## TECHNICAL MEMO

SUBJECT: 40 Beechcliffe Street Site Plan - Stormwater Management Facility (SWMF) Design and Volumetric Analysis

OUR FILE: 24-1416

CITY FILE: D07-12-25-0091

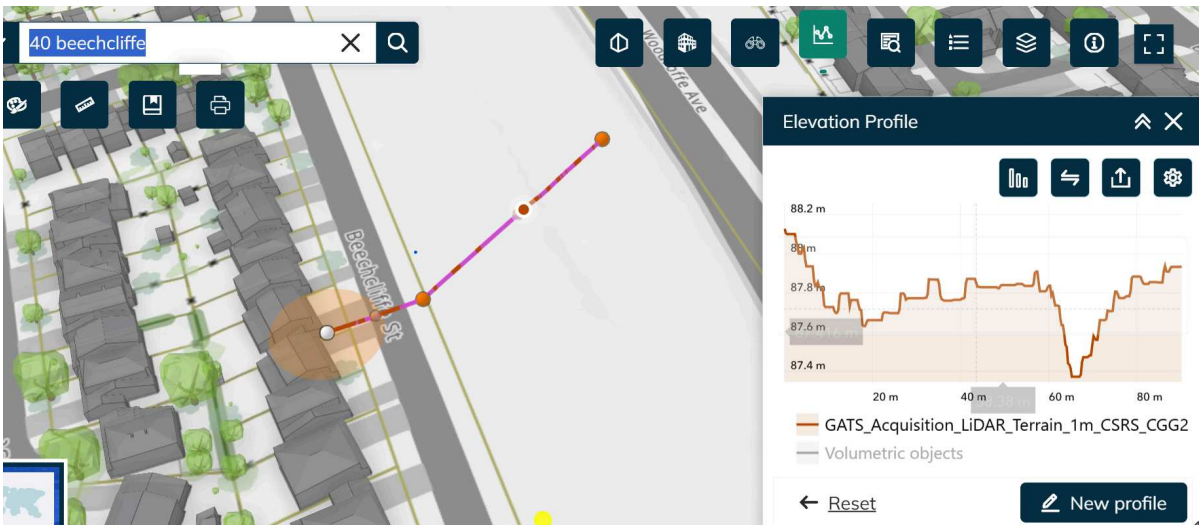
As mentioned over the phone, this site was providing storage relief to the overland flow from Beechcliffe Street under existing conditions. See image below. The proposed development will not only remove this existing storage but also add more flow to Beechcliffe Street. Therefore, we believe the total capture required in the ROW minor system will be much greater than what is described in the email below to ensure there is no negative impact on existing properties from the increased overland flow.

This memorandum discusses the design rationale, volumetric assessment, and operation of the proposed Stormwater Management Facility (SWMF) for the 40 Beechcliffe Street development. The design has been prepared in response to direction provided by the City via email dated November 13, 2025 (attached for reference).

Under existing conditions, the subject site provides relief storage for overland flow originating from Beechcliffe Street. The proposed development removes a portions of this storage volume through grading modifications required to support the site plan. As directed by the City, a compensatory storage strategy has been developed by DSEL to re-establish equivalent relief storage capacity within the subject lands.

DETAILS

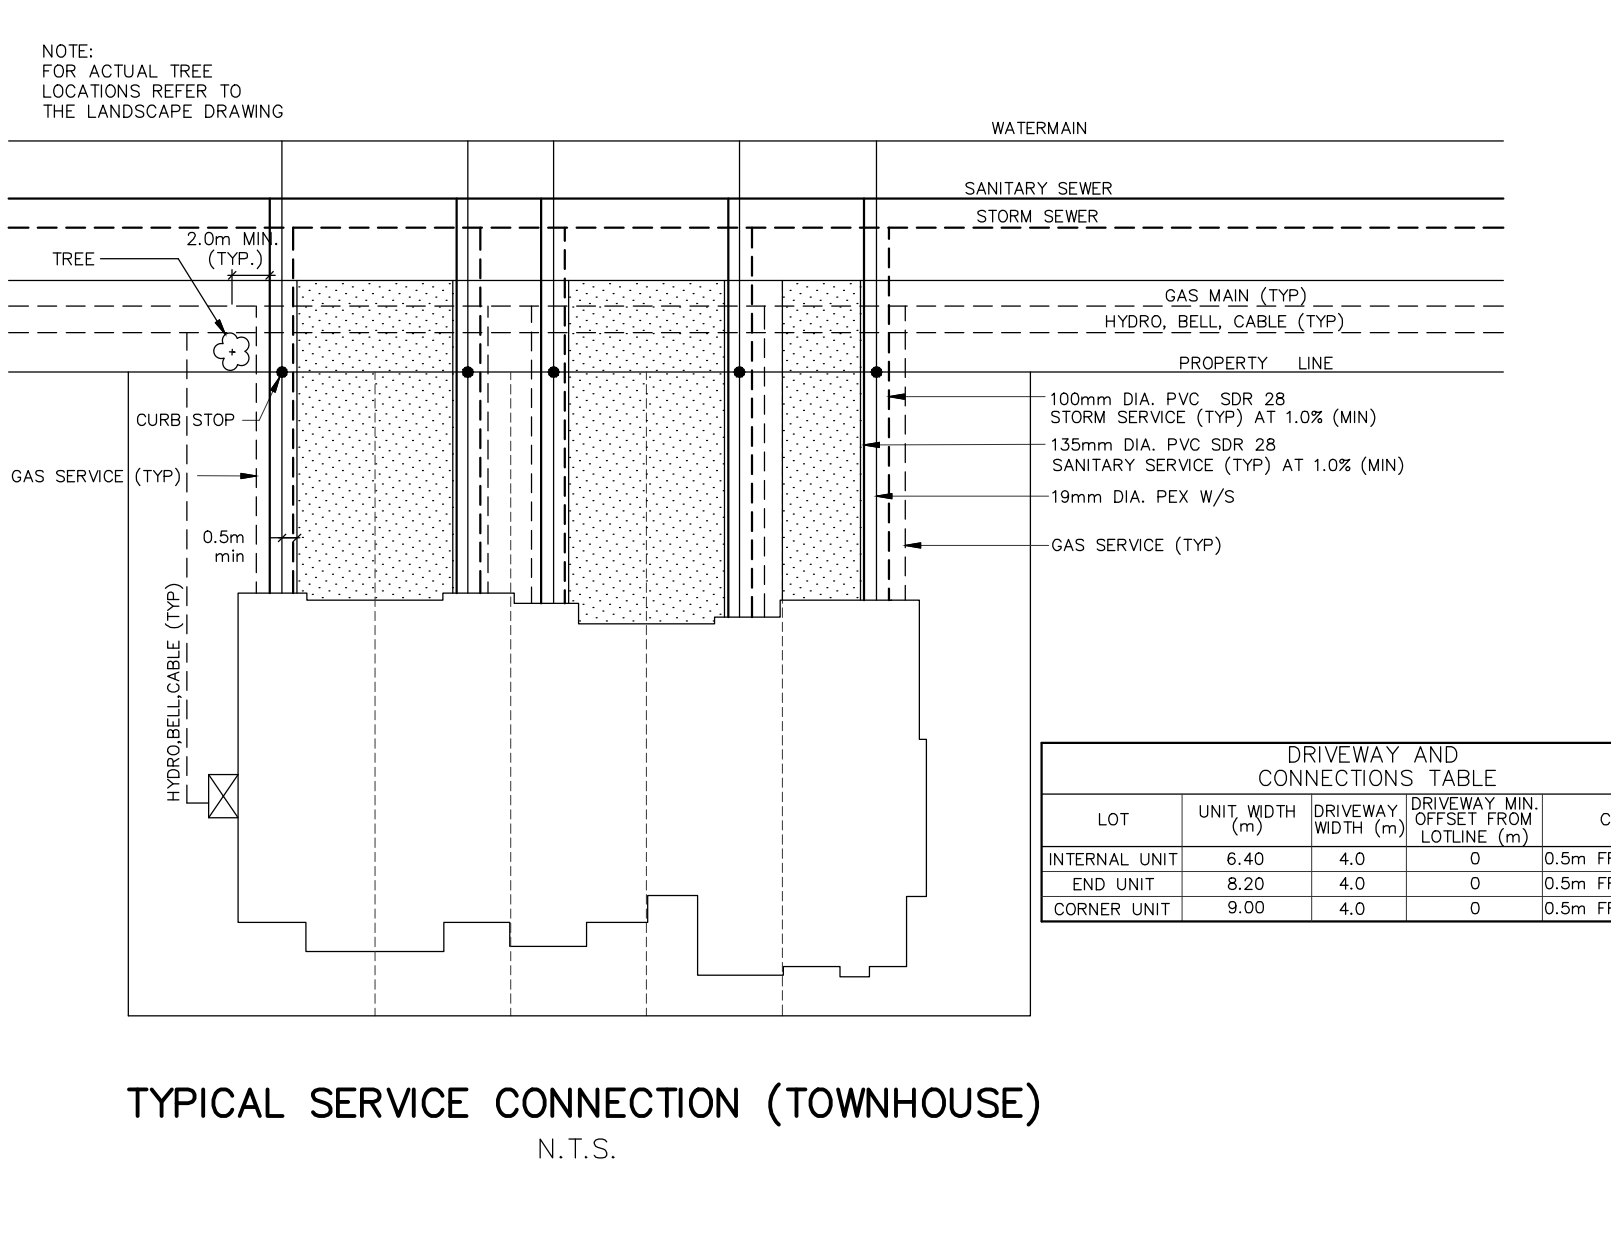
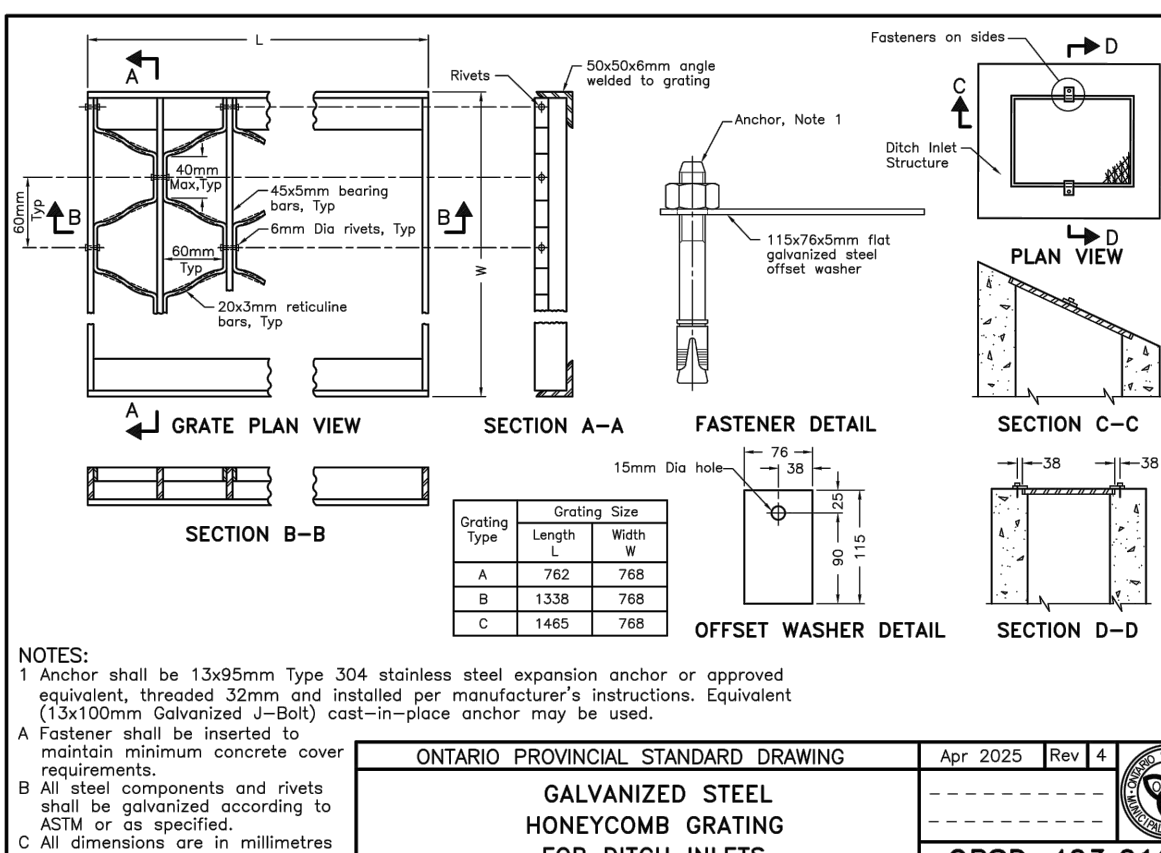
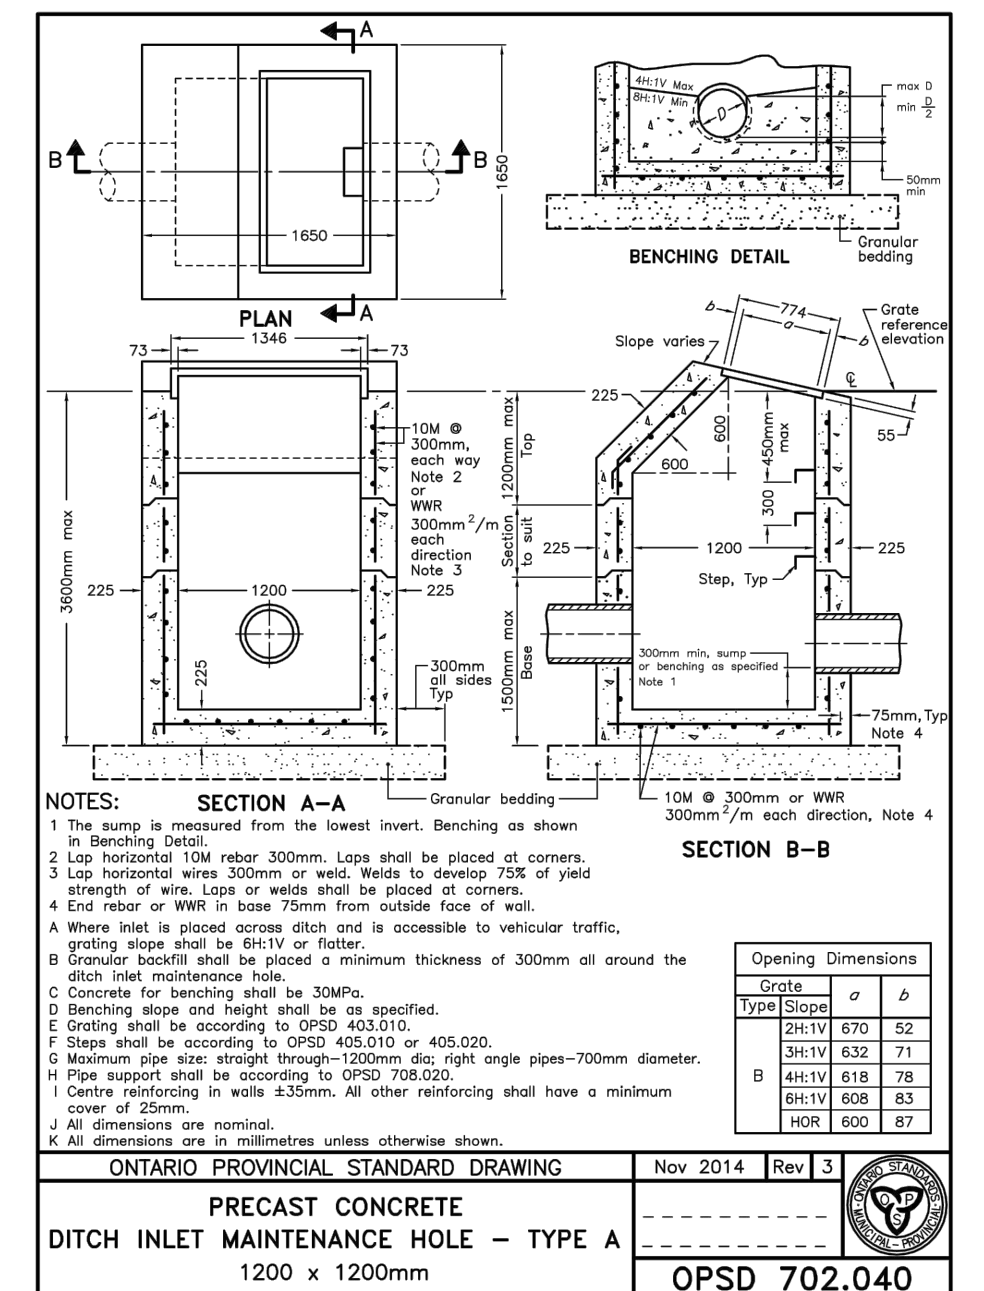
**Inlet/Outlet Infrastructure:** A ditch inlet structure is proposed to manage flow transition between the pipe network and the pond. Details of the structure are shown on DSEL drawing 2.
